TRUCK, DUMP, HEAVY, MC3 (MACK)
EXHAUST TAIL PIPE

MODIFICATION INSTRUCTION

FIG 1 - STRAIGHT EXHAUST TAIL PIPE

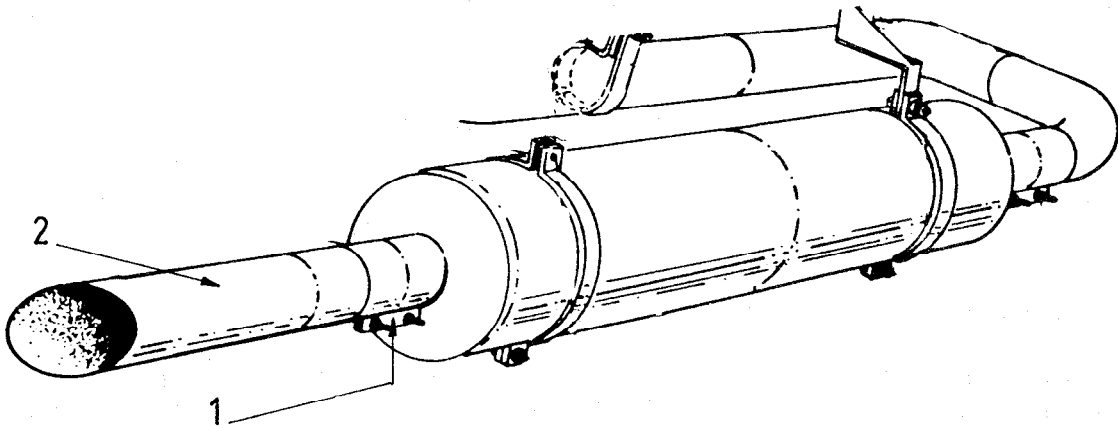
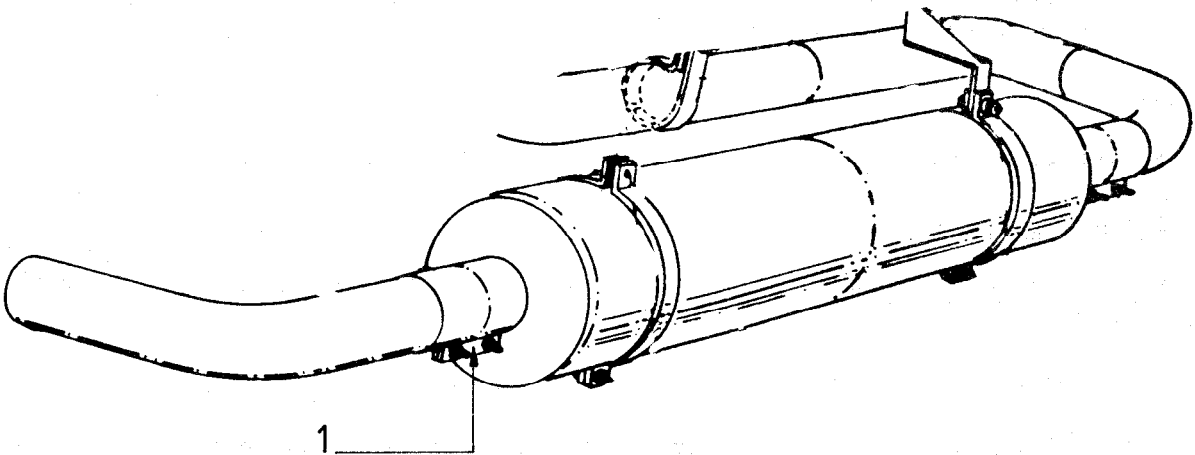
1. This instruction replaces VEHICLE G 737-2 Issue 1 which is to be destroyed.
2. This instruction details the replacement of the straight exhaust tail pipe with a curved pipe to deflect exhaust emissions rearward and eliminate the discomfort being caused to other road users.

8. To carry out the modification, proceed as follows:
 - a. Loosen the clamp, item 1 in Fig 1 and remove the exhaust tail pipe, item 2.
 - b. Using the original clamp, item 1 in Figs 1 and 2, fit the new exhaust tail pipe, item 1 from Table 1 as shown in Fig 2. Ensure the tail pipe is facing rearward and slightly downward and tighten the clamp.
